Grid Code Modifications H/04 & SA/2004

Responses to Ofgem's consultations 07/05 and 08/05

May 2005

BWEA response to Grid Code Consultation H/04 and SA/2004 and Ofgem Regulatory Impact Assessment

Figure 4.1b Power Park Module Reactive Power Envelope

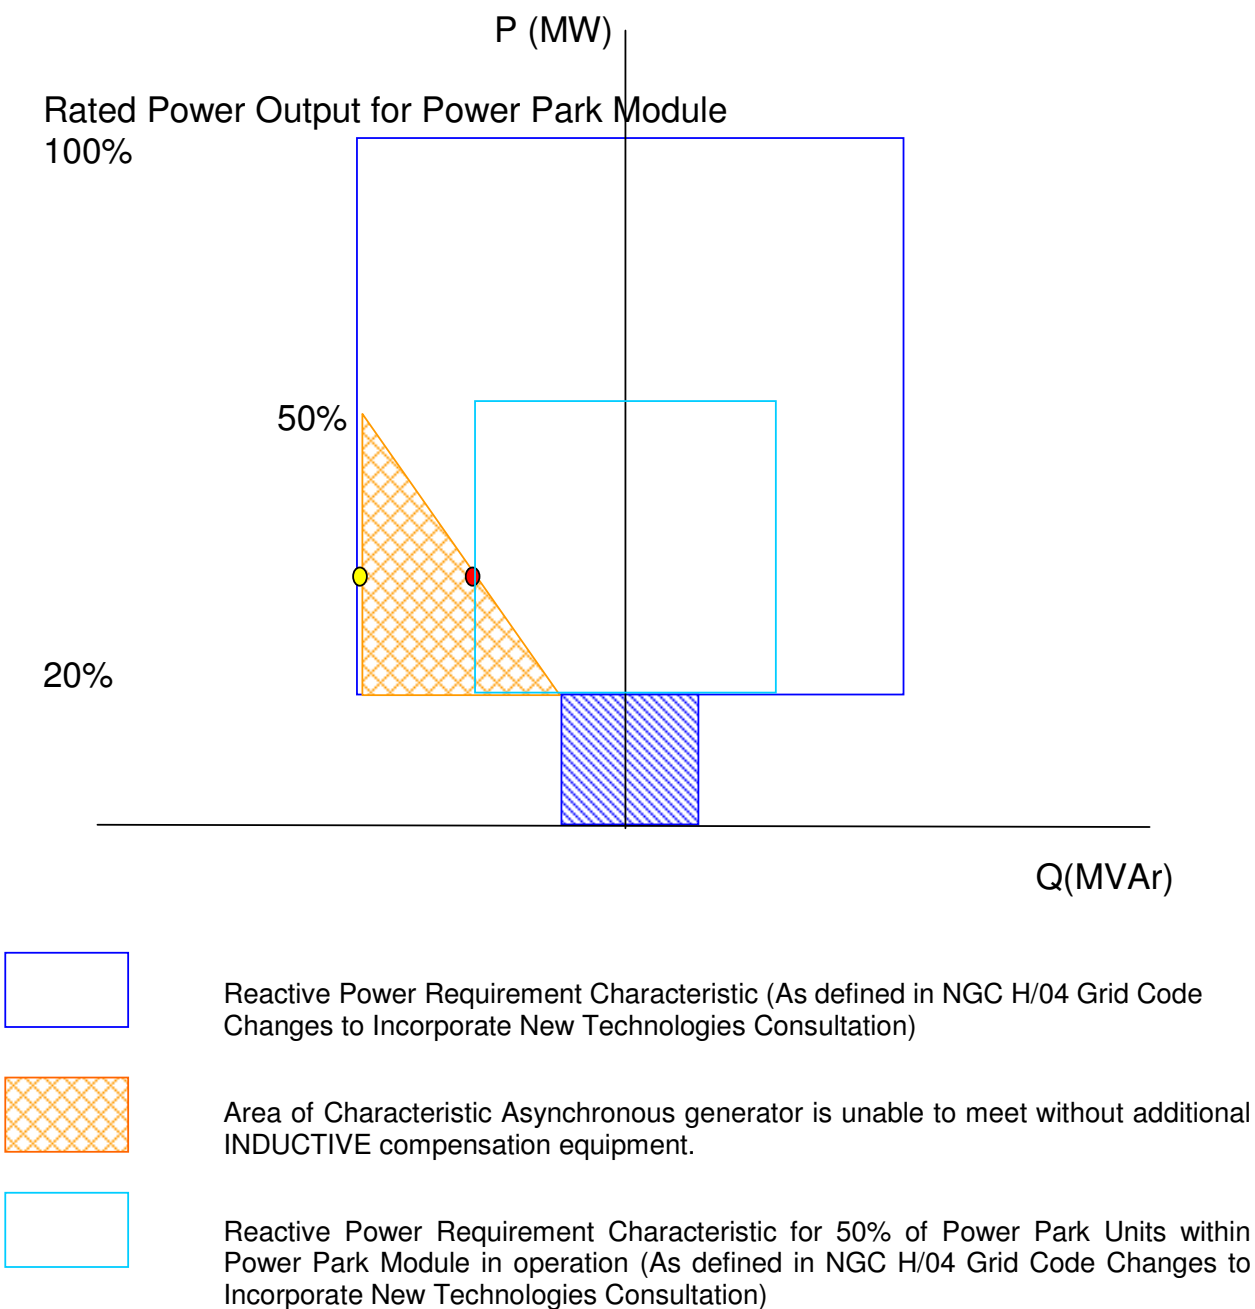
The amount of reactive power an asynchronous generator absorbs increases as its output power increases (as shown by the red characteristic in Figure 4.1a). Therefore additional capacitive compensation is required to allow reactive power to be exported from the wind farm onto the network, in order to comply with the reactive power requirement as defined in the proposed Grid Code changes. However, the shape of the proposed reactive power requirement characteristic (Figure 1 in CC6.3.2 (c)) also means that extra INDUCTIVE compensation may be required in order for the wind farm to be able to absorb the same amount of reactive power at 20% active power output as it does at 100% active power output. It is the BWEA's opinion that the cost of this extra reactive equipment is not justified by a system need. Hence the BWEA recommends that the proposed GB Grid Code reactive requirement characteristic be amended to account for the P/Q characteristic of the asynchronous generator between 20% and 50% of its active power output (as defined by the removal of the hatched triangle in Figure 4.1b). Such an amendment would bring the GB Grid Code into line with the reactive requirement in the ESB Grid Code in Ireland.

If this amended reactive requirement is extended to a power park module as a whole, it can be seen from Figure 4.1b that the same reactive power output is achieved for 100% of the Power Park Units (PPUs) operating at 25% of active power output, as for 50% of the PPUs operating at 50% of their active power output (indicated by the red dot).

- CC 6.3.2 (c) Figure 1 amended
- CC 6.3.2 (d) remove due to retrospective applications
- CC 6.3.2 (new d) new clause describing requirements below 20% of rated power

Figure 4.3a simplified windfarm single line diagram

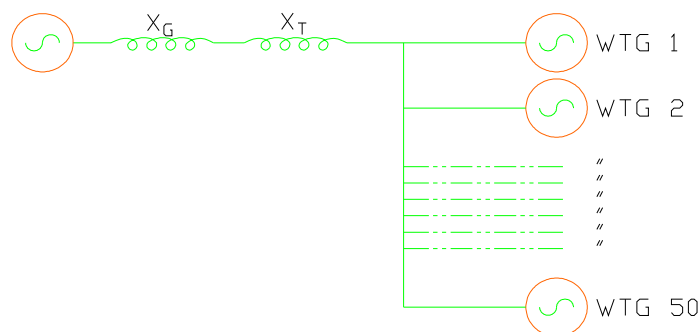
Consider a windfarm connection with a simplified design shown in figure 4.3A.

Figure 4.3a represents a windfarm of 50 turbines. The impedance X_g determines the fault level at the point of connection. The impedance X_t represents the grid transformer and the turbine transformers and is selected with a high enough value to provide sufficient retained voltage on the generator terminal in the event of a grid fault. However, the impedance X_t cannot be infinite due to costs, voltage regulation and the losses generated in the associated resistance. Figure 4.3b shows the effects of a grid fault with the whole windfarm operating

Figure 4.3b Grid Fault with all turbines operating

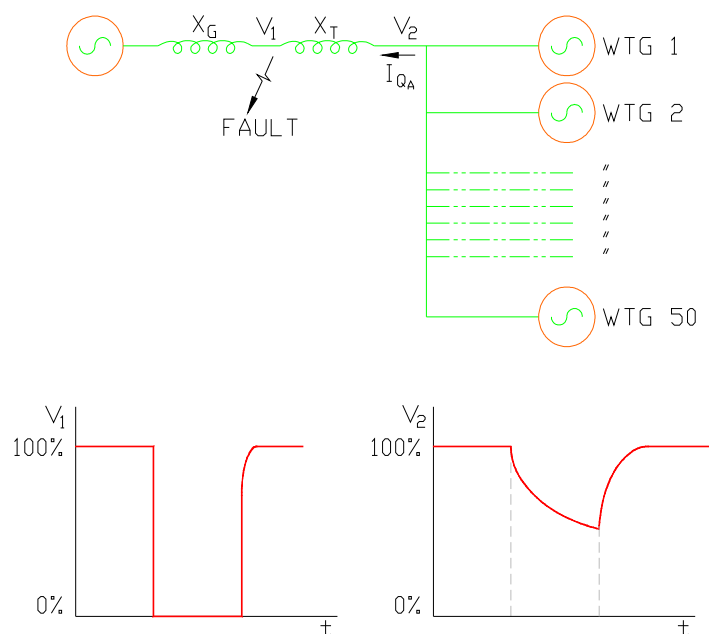
Figure 4.3b shows the voltage at the fault, V_1 , falling to zero for a short duration until the fault is cleared. The voltage at the generator terminals, V_2 , falls more slowly due to the reactive current I_{QA} supplied, for example, by the demagnetisation of the generators. In this example the voltage V_2 remains sufficiently high due to the impedance X_t and the fault current I_{QA} to allow the generators to ride through the fault.

Figure 4.3c Grid Fault with one turbine operating

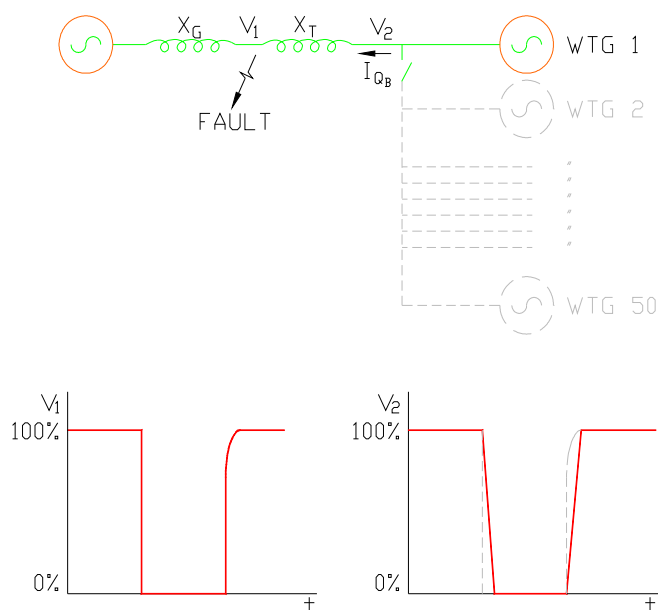
To emphasise the point in this example Figure 4.3 c assumes that only one wind turbine is connected. However the same principles apply for any example where not all the turbines are connected.

Figure 4.3c shows the impact when fewer turbines are connected during the fault and in this case only one turbine is connected. The voltage profile at the fault, V_1 , is effectively unchanged. However, the voltage at the generator terminals, V_2 , has now fallen (in this example to zero), as the reactive current I_{GB} is now $1/50^{\text{th}}$ of its previous value whereas the value of the impedance X_t is unchanged. The voltage V_2 is now no longer high enough to allow the generator to ride through the fault.

Figure 1 (revised)

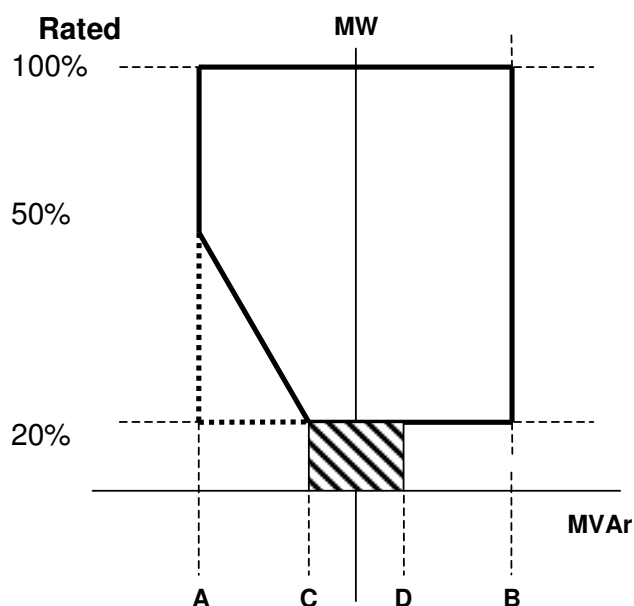
BWEA expects to see the same definitions applied to Scotland as England and Wales.

This clause is reinserted from NGC H/04 consultation June 2004 to cover the shaded area of figure 1.

- (c) Subject to the provisions of CC.6.3.2 (d) below, all **Non-Synchronous Generating Units, DC Converters** (excluding current source technology) and **Power Park Modules** (excluding those connected to the **Total System** by a current source **DC Converter**) with a **Completion Date** on or after 1 January 2006 must be capable of supplying **Rated MW** output at any point between the limits 0.95 **Power Factor** lagging and 0.95 **Power Factor** leading at the **Grid Entry Point** ~~in England and Wales or at the HV side of the 33/132kV or 33/275kV or 33/400kV transformer for Generators directly connected to the GB Transmission System in Scotland [GN1]~~ (or **User System Entry Point** if **Embedded**). With all **Plant** in service, the **Reactive Power** limits defined at **Rated MW** will apply at all **Active Power** output levels above 20% of the **Rated MW** output as defined in Figure 1. These **Reactive Power** limits will be reduced pro rata to the amount of **Plant** in service.

Point A is equivalent (in MVar) to: 0.95 leading **Power Factor** at **Rated MW** output
 Point B is equivalent (in MVar) to: 0.95 lagging **Power Factor** at **Rated MW** output
 Point C is equivalent (in MVar) to: -5% of **Rated MW** output
 Point D is equivalent (in MVar) to: +5% of **Rated MW** output

- (d) In the shaded area of Figure 1 the operation is at the discretion of the **Generator** or **DC Converter Station** owner.

Figure 5

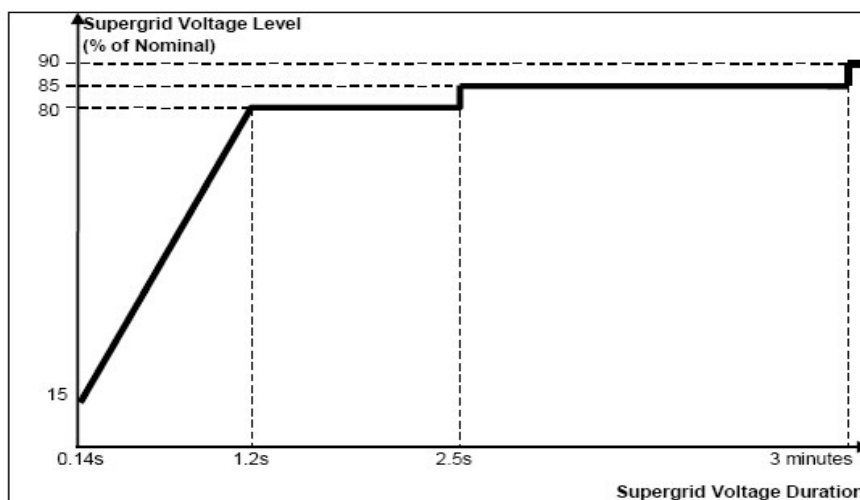
Option 4 Paragraph CC.6.3.15(b)(ii) and (iii)

In addition to the requirements of CC.6.3.15 (a) each **Generating Unit** or **Power Park Module** and / or any constituent element, each with a **Completion Date** on or after the ~~[Grid Code change implementation date]~~ 1st April 2006 shall:

- (i) remain transiently stable and connected to the **System** without tripping of any **Generating Unit** or **Power Park Module** and / or any constituent element, for balanced **Supergrid Voltage** dips and associated durations anywhere on or above the heavy black line shown in Figure 5. Appendix 4 and Figures CC.A.4.3 (a), (b) and (c) provide an explanation and illustrations of Figure 5; and,

- (ii) provide **Active Power** output, during **Supergrid Voltage** dips as described in Figure 5, at least in proportion to the retained balanced voltage at its Grid Entry Point Supergrid Voltage (or the retained balanced voltage at the **User System Entry Point** if **Embedded**) and shall generate maximum reactive current without exceeding the transient rating limits of the **Generating Unit** or **Power Park Module** and any constituent element; and,

- (iii) restore **Active Power** output, at a minimum rate of 10% of Rated MW per second, following Supergrid Voltage dips as described in Figure 5, following within 1 second of restoration of the voltage at the Grid Entry Point Supergrid Voltage to the minimum levels specified in CC.6.1.4 (or within 1 second of following restoration of the voltage at the **User System Entry Point** to 90% of nominal or greater if **Embedded**), to at least 90% of the level available immediately before the occurrence of the dip except in the case of a **Non-Synchronous Generating Unit** or **Power Park Module** where there has been a reduction in the **Intermittent Power Source** in the time range in Figure 5 that restricts the **Active Power** output below this level.
